STATE OF NORTH CAROLINA  
DEPARTMENT OF TRANSPORTATION

**Addendum No. 1**

Contract No.: DA00585

*Drainage, Base and Shoulder Reconstruction on SR 1128 Weeping Mary Road in Bertie County*

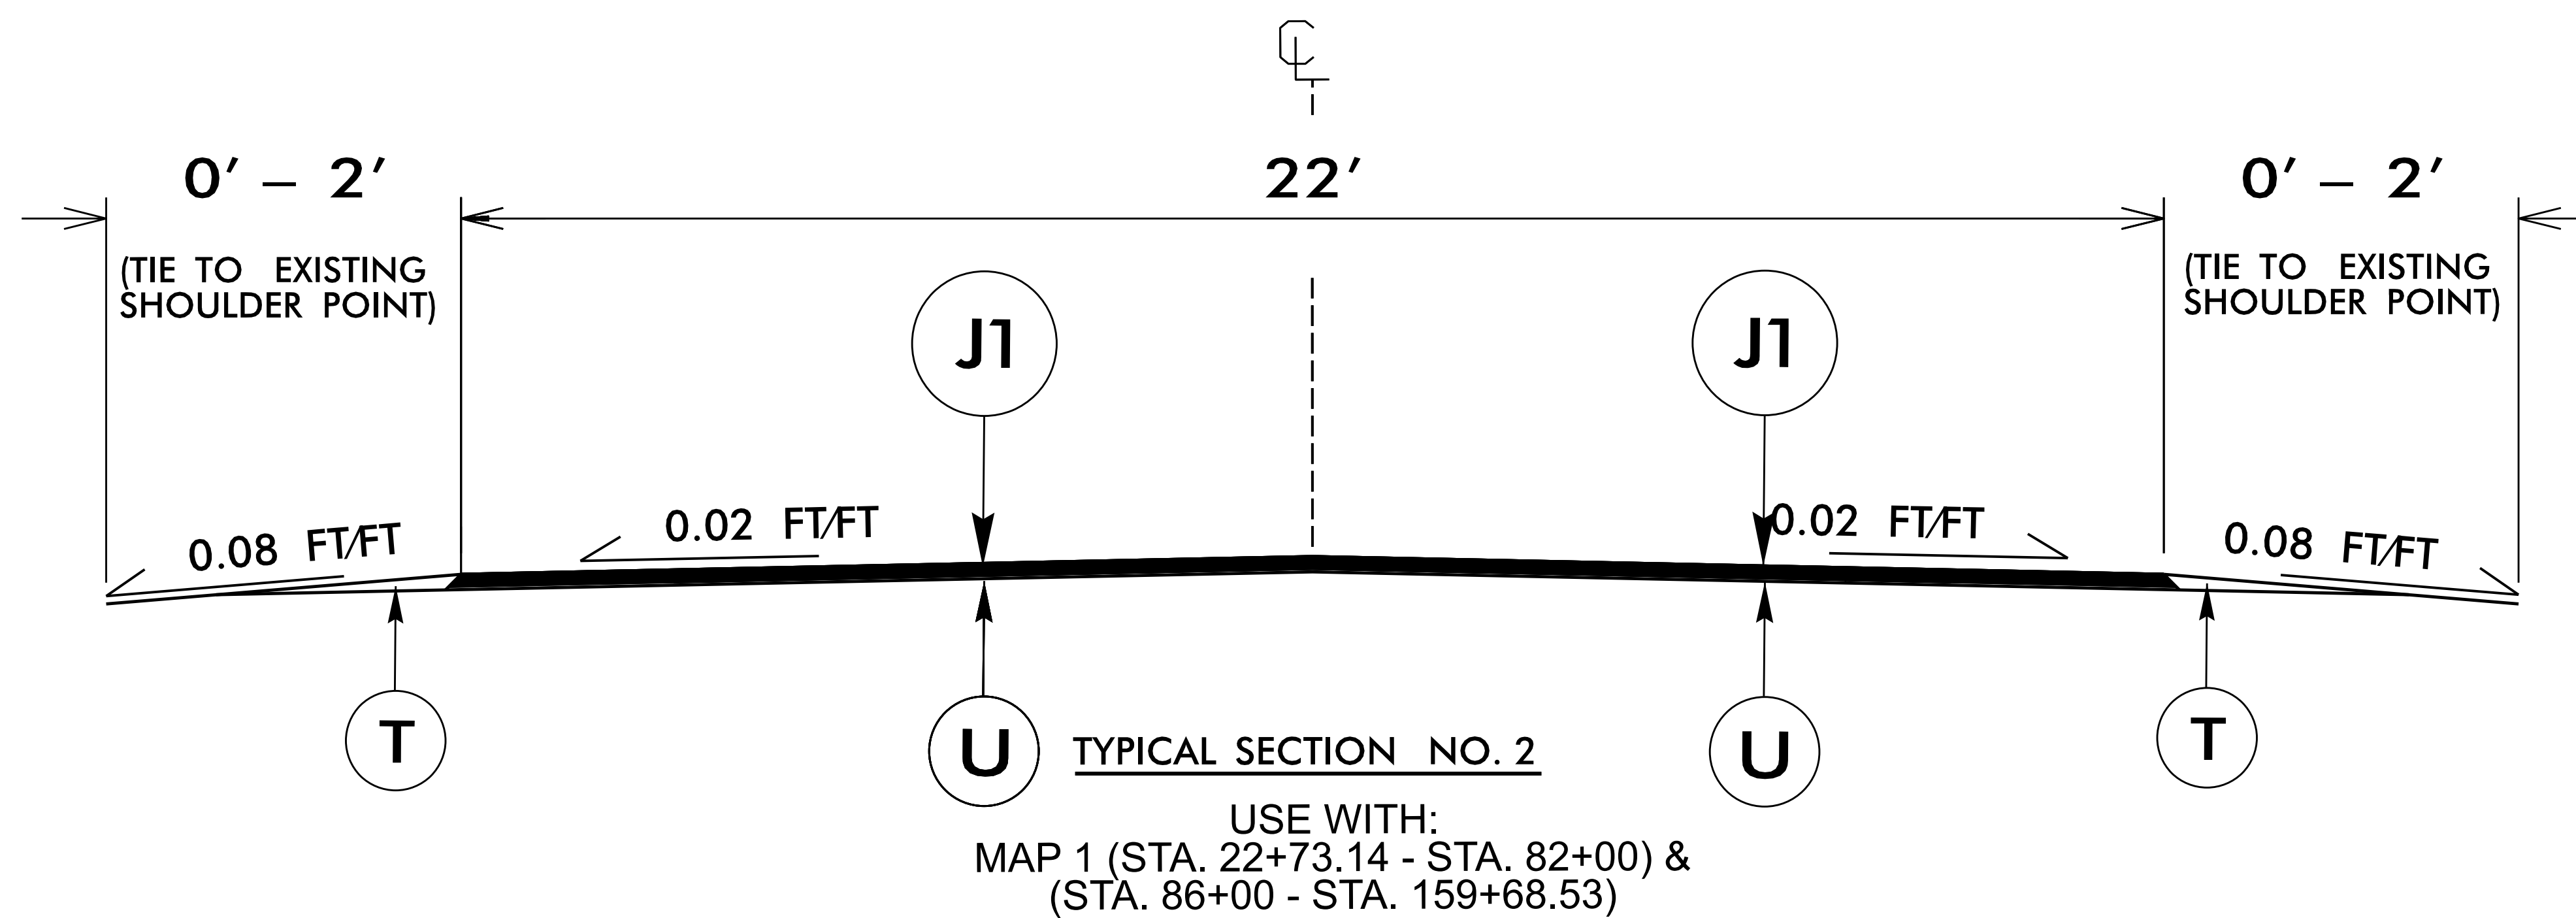
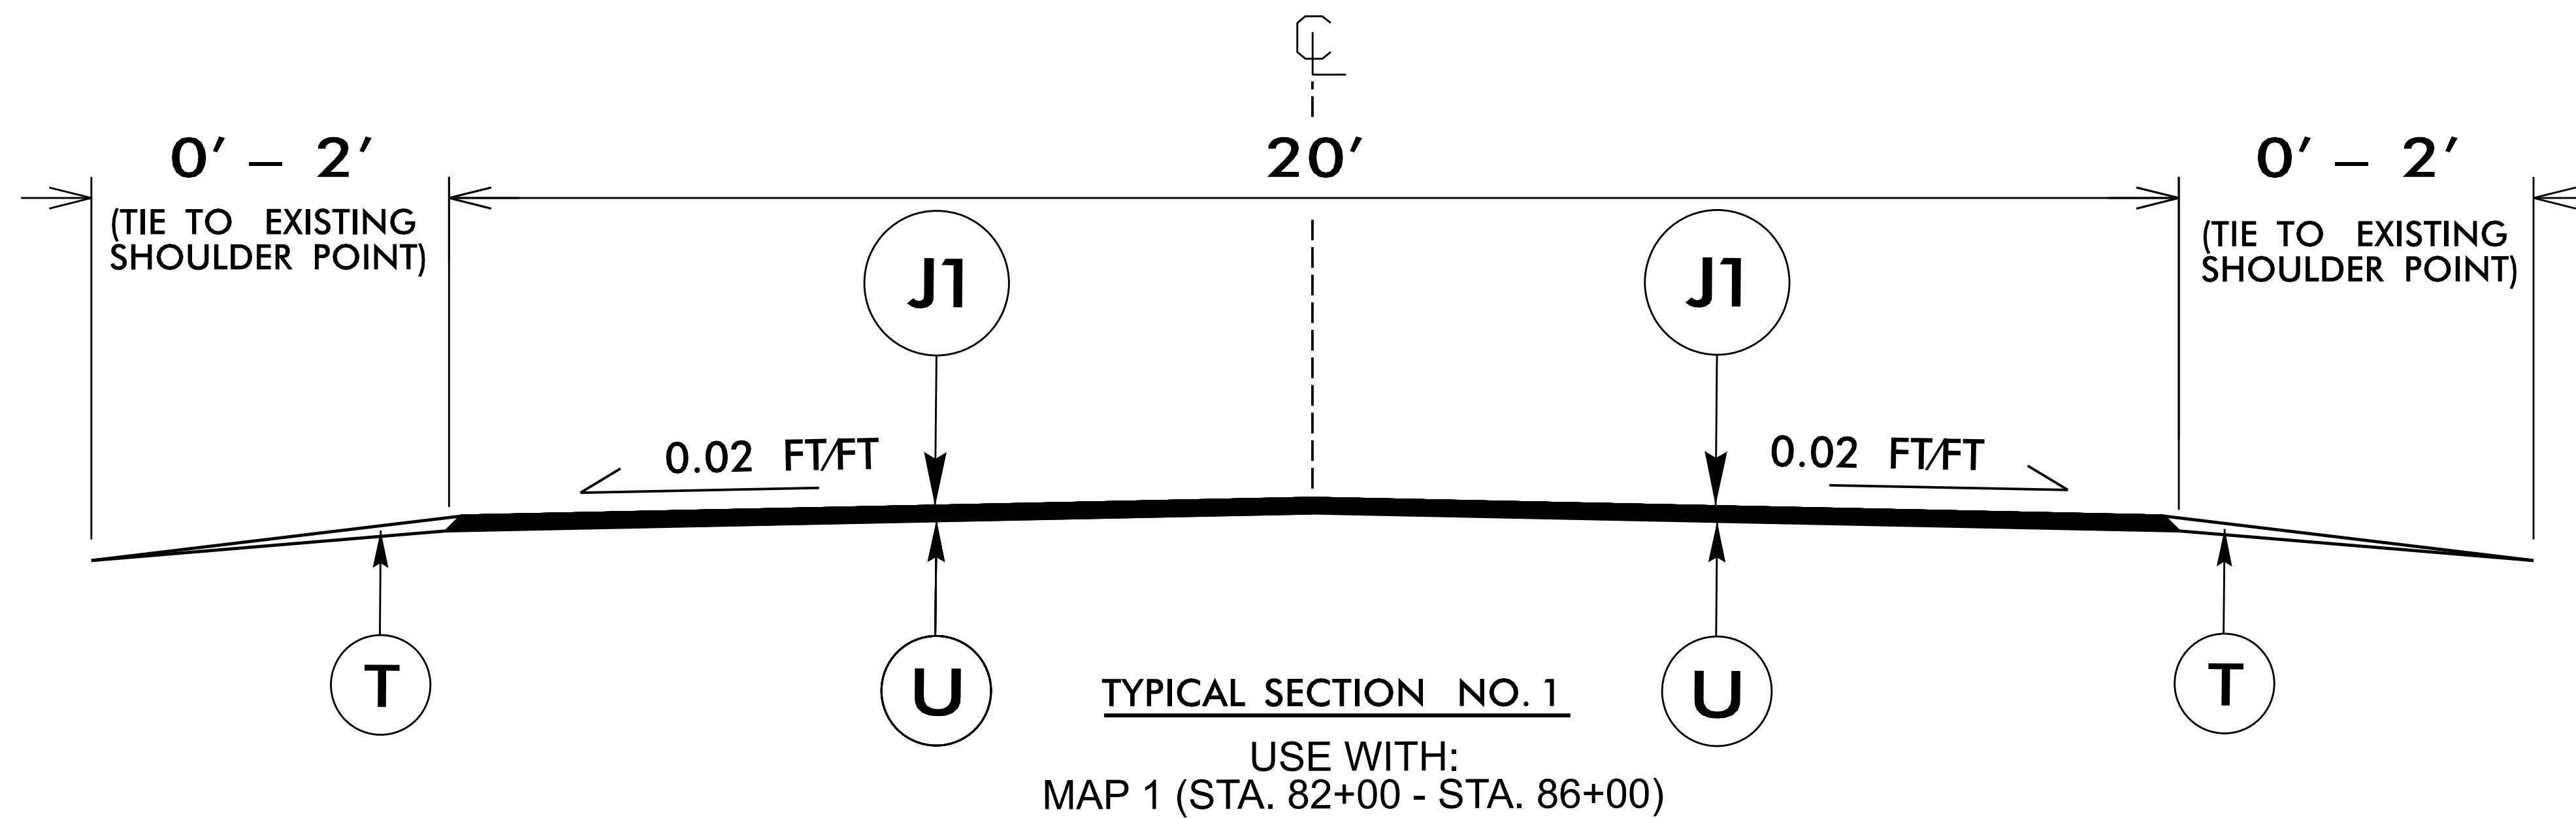
Plan Sheet No. 4 "Typical Section #1 & #2" have been revised to clarify the width of the proposed "Aggregate Base Course". Please replace the original Plan Sheet No. 4 "Typical Section #1 & #2" with the attached revised Plan Sheet No. 4 "Typical Section #1 & #2".
